Limitorque Corporation

Re: Limitorque Corporation
Part 21 Notification

Subject: 10 CFR Part 21 Notification

A LIMATORQUE MAINTENANCE UPDATE

FIGURE 4

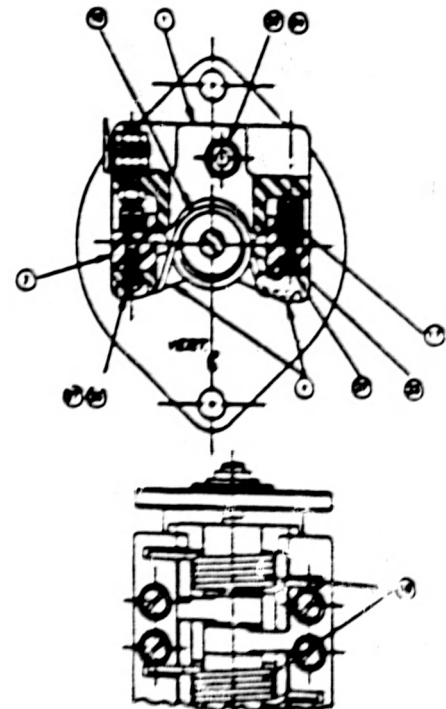
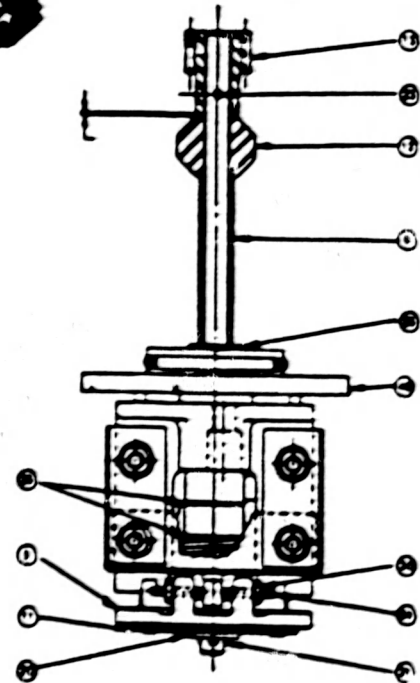
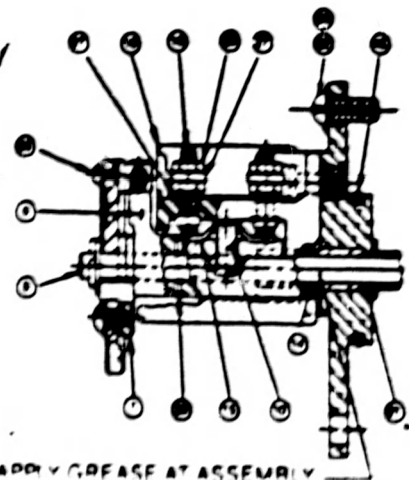
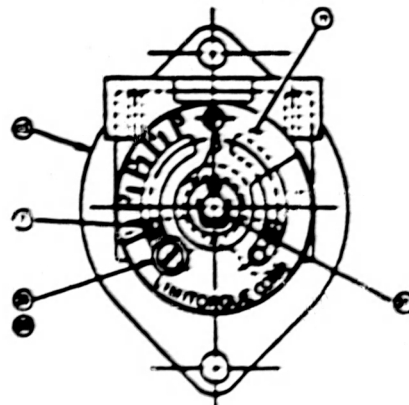
Figures 1, 2, and 3 show the torque switch and limit switch designs that were used prior to qualification testing. All of our qualification tests have used the limit and torque switch designs shown in our maintenance manual (Figures 4, 5, and 6.)

There have been a number of reported incidents of failures of the pin that holds the arm to the torque switch shaft (Pc. No. 23 of Figure 4). In the most recent case reported to Limitorque, the failed pin was subjected to a metallurgical evaluation which indicated the failure was caused by a single overload condition.

It is Limitorque's conclusion that the cause of the pin failure was due to the actuator being declutched while the motor was running, which is abnormal use and not recommended. The Limitorque actuator declutch mechanism for all size SMB actuators was not designed with the intention that the declutch mechanism be operated while the motor is running. In addition to the reported failure of the torque switch arm pin on the SMB-00, we have also seen cases of motor pinion, worm shaft gear, and worm shaft clutch failures of the SMB-0 through SMB-5 resulting from the unit being declutched while the motor is in operation. We recommend that training programs conducted for plant personnel include instruction on the proper use of the declutch mechanism.

ATTACHMENT #1

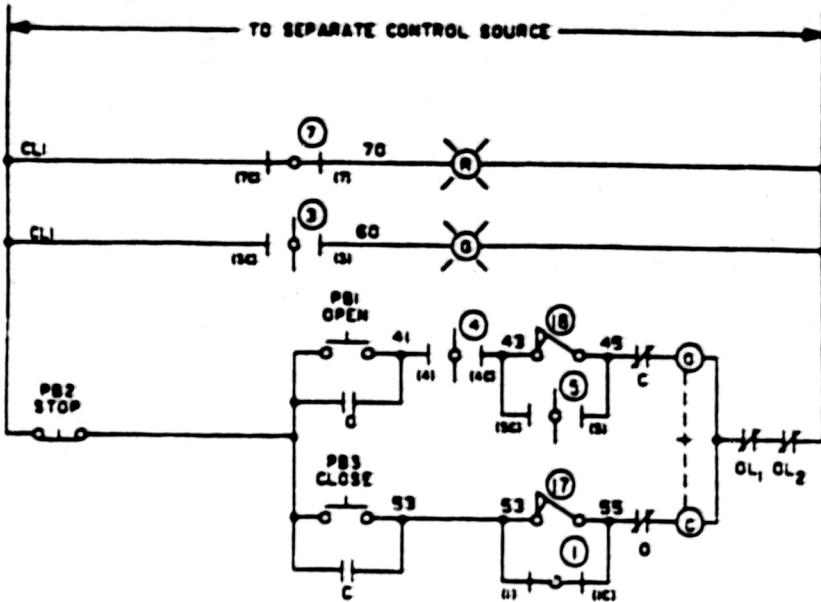
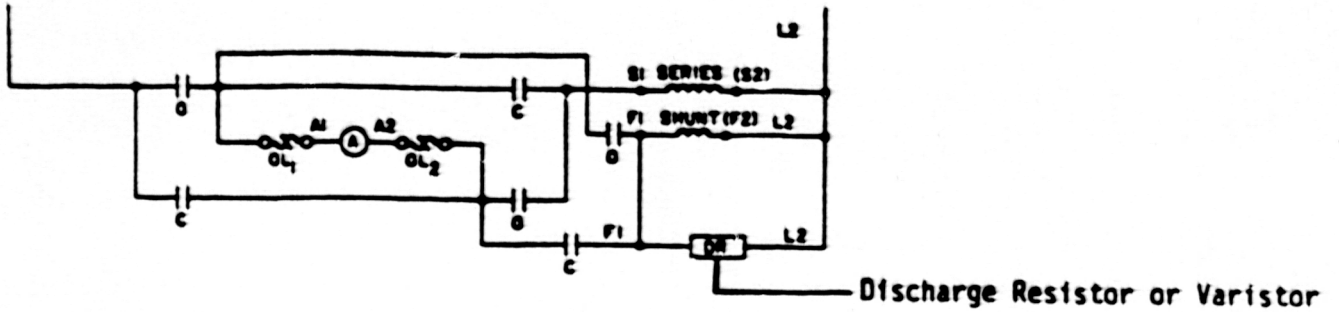
3. The cable size used for the DC motors should be sized to allow for five times full load current flow at the minimum voltage conditions. Accident ambient temperature conditions should be taken into account in determining cable resistance. Attachment 1 is an example of the typical calculations which should be performed.

Available current draw is considerably less than required. The motor performance curve indicates that 52.26 amps will produce approximately 40 foot-pounds from a motor rated for 60 foot-pounds of starting torque.

If the above example is for an existing installation, you may want to determine the motor torque required to operate the valve under design conditions or at the existing torque switch setting. This application would be acceptable if the motor required torque is less than 40 foot-pounds. In a case where the required motor torque is greater than 40 foot-pounds, you would then want to evaluate the options for modifications to the actuator or a change in cable size. The actuator change in this situation would be to increase the gear ratio and thus reduce the torque required from the motor. An increased gear ratio will also result in a proportionally longer stroke time.
